Service Action: Replace Cover on Battery Positive Terminal

F22 (2 Series Coupe)

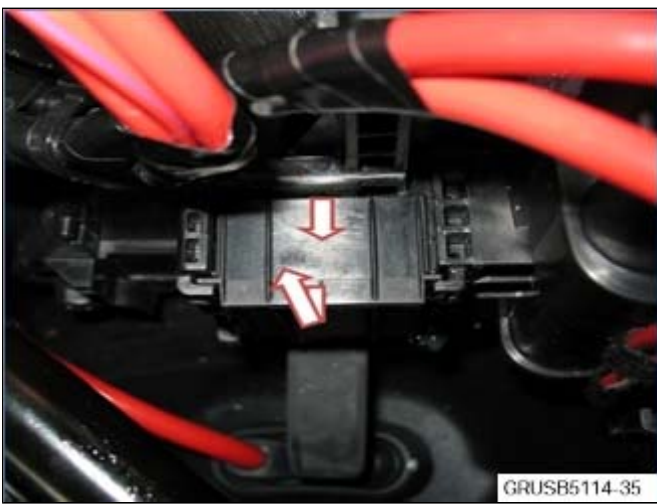
- This picture shows the installation location of the cover to be replaced, below the battery positive cable.

- Remove the cover on the battery positive terminal in the direction of the arrow, and replace it.

Replace the cover for the battery positive cable connection point in the engine compartment.
